Access Compliance Report

Public Rights-of-Way

(Curb Ramps)

Intersection ID: 19071	Main Street: S_TRYON_ST	Cross Street: LAND_GRANT_RD	Location: SE
ADA ID: 2AD13EB1CCA6	Ramp Type: PerpDiag	Initial Pass/Fail: Fail	Overall Compliance: No
Severity Score: 12.5			
Codes/Mitigation Info/Possible Solution		Field Measurements/Component Compliance

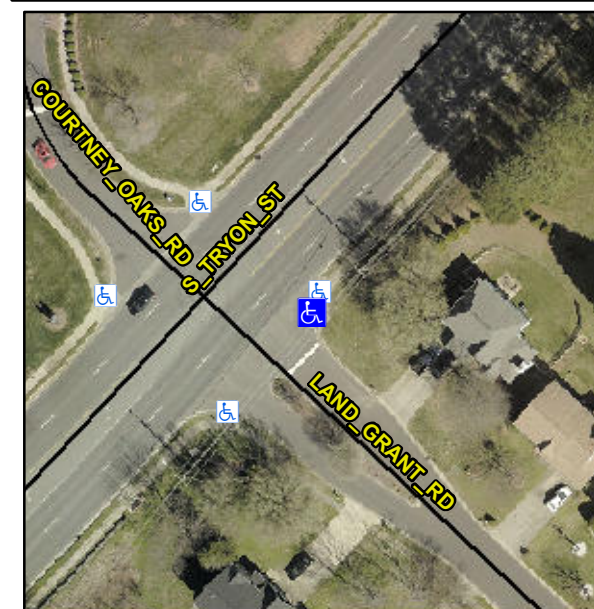
Compliance	Description	Data	Compliance	Description	Data
N/A	Ramp Length (in)	82.0	Yes	Ramp Slope (%)	6.4
Yes	Ramp Width (in)	48.0	No	Ramp XSlope (%)	6.6
N/A	Flare Type LT	N/A	N/A	Flare Type RT	N/A
N/A	Flare Slope LT (%)	N/A	N/A	Flare Slope RT (%)	N/A
N/A	Flare Traversable LT?	N/A	N/A	Flare Traversable RT?	N/A
N/A	Landing Length (in)	N/A	N/A	DWS Provided?	N/A
N/A	Landing Width (in)	N/A	N/A	DWS Contrast?	N/A
N/A	Landing Slope (%)	N/A	N/A	DWS Length (in)	N/A
N/A	Landing X Slope (%)	N/A	N/A	DWS Full Width?	N/A
N/A	Landing Curb? (Y/N)	N/A	N/A	DWS Offset (in)	N/A
N/A	Shared Landing?	N/A			
N/A	Gutter Ponding?	N/A	N/A	Gutter Slope (%)	N/A
N/A	Gutter Lip Ht (in)	N/A	N/A	Gutter X Slope (%)	N/A
N/A	Painted X Walk1?	No	N/A	Painted X Walk2?	No
	X Walk 1 Direction	To NW		X Walk 2 Direction	To SW
N/A	X Walk 1 Width (in)	N/A	N/A	X Walk 2 Width (in)	N/A
	X Walk 1 Slope (%)	6.8		X Walk 2 Slope (%)	2.1
	X Walk 1 X Slope (%)	0.7		X Walk 2 X Slope (%)	7.3

N/A	Ramp inside XWalk1?	N/A	N/A	Ramp inside XWalk2?	N/A
	Road Slope (%)	6.3	N/A	Clear Space?	N/A
	Road X Slope (%)	6.7	N/A	Clear Space to XWalk (in)	N/A
N/A	Any Obstructions?	N/A	N/A	Storm Grate/Utility Hazard?	N/A
	Obstruction Type			Storm Grate/Utility Type	
		N/A			N/A
			Yes	Surface Condition? (G/P)	Good

Remove & Replace Curb Ramp With Two New Directional Ramps or Equivalent.

R304.5.3
